Tujunga Spreading Grounds Enhancement Project Final Environmental Impact Report

CEQA Final Environmental Impact Report

April 2013

Figure 2-3

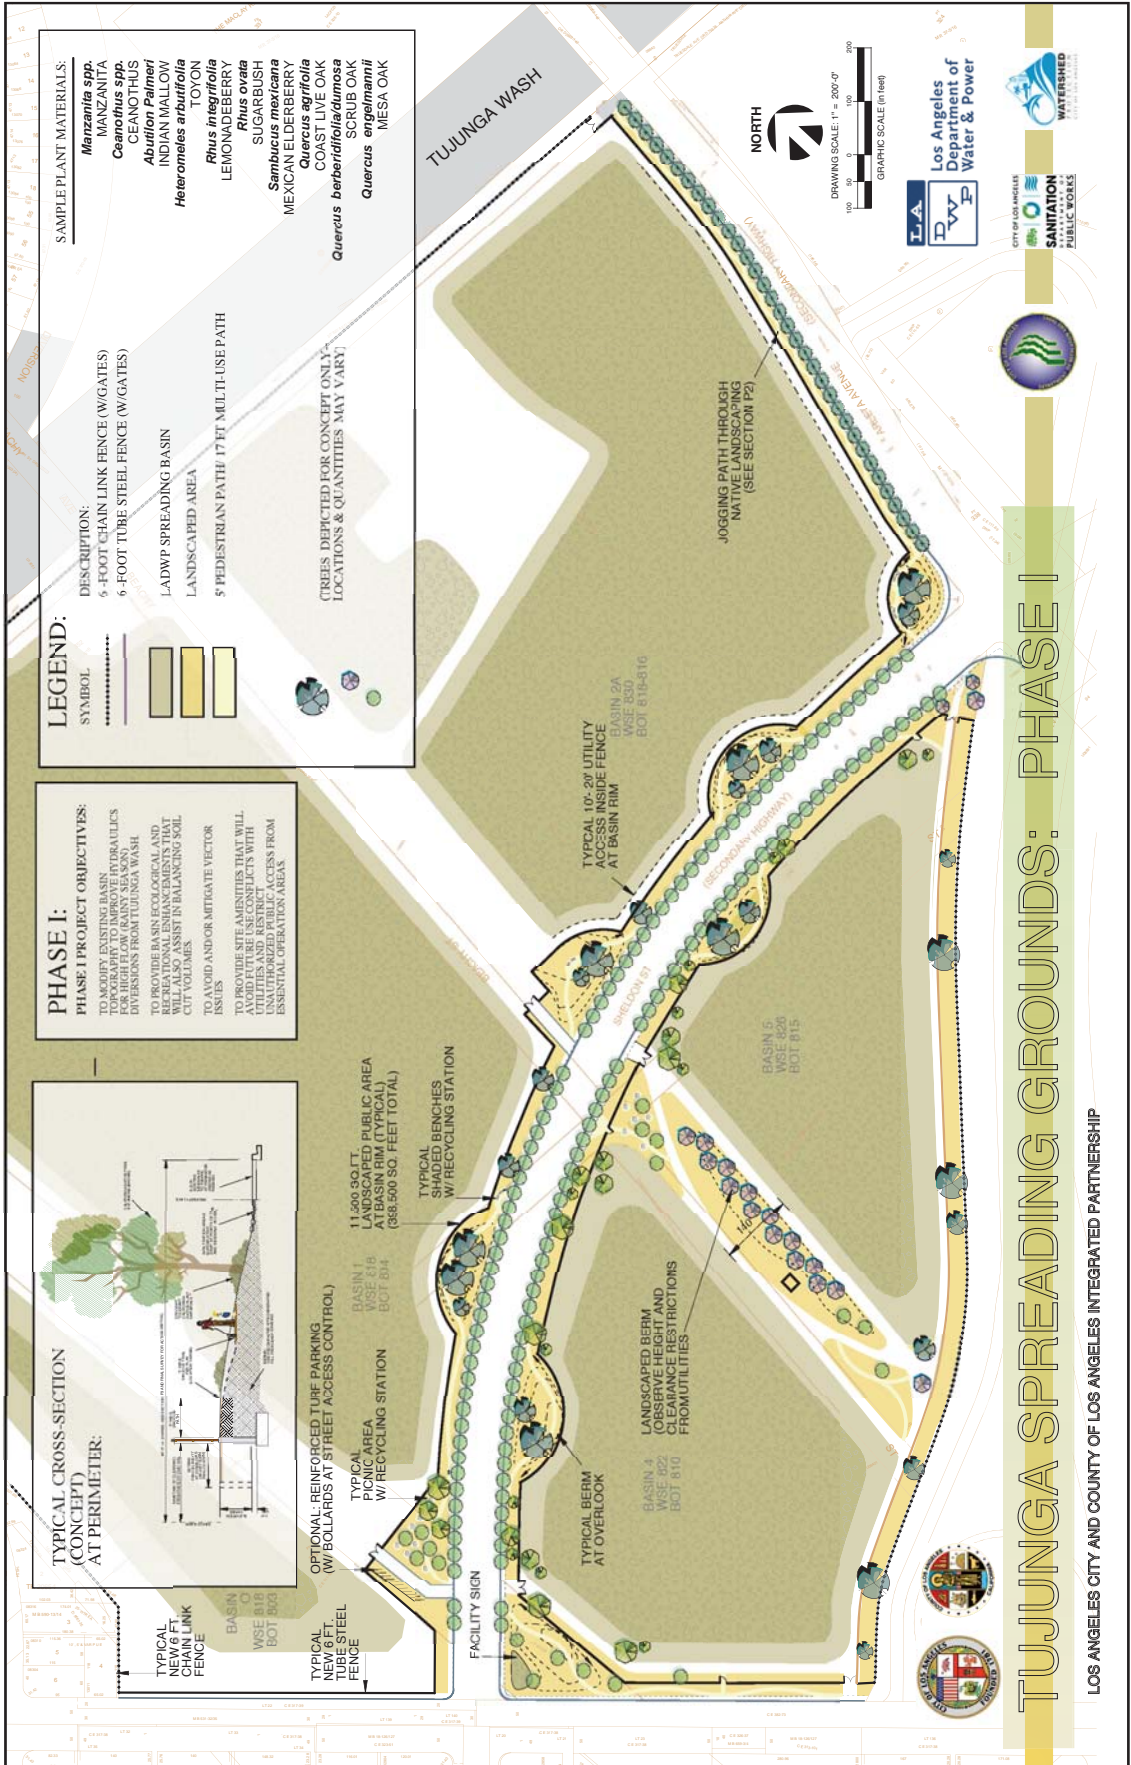
6-1 Upgrade of the landscaping of the TSG facility is included in the proposed project. Conceptual renderings of the proposed improvements are included in Section 2 of the Final EIR. The specific facilities to be installed have not been finalized but may include trails and jogging paths, trees and other plantings, and benches. Native species with low water requirements will be used as plantings to the extent feasible. Landscape maintenance is noted in the Draft EIR (Section 3.4). As compared with the existing condition of the site, the project-related impact on aesthetics will be beneficial.

6-3 Please see the conceptual renderings of the proposed recreational amenities included in Section 2 of the Final EIR. Final design of these elements (trails and jogging paths, trees and other plantings, and benches) is on-going.
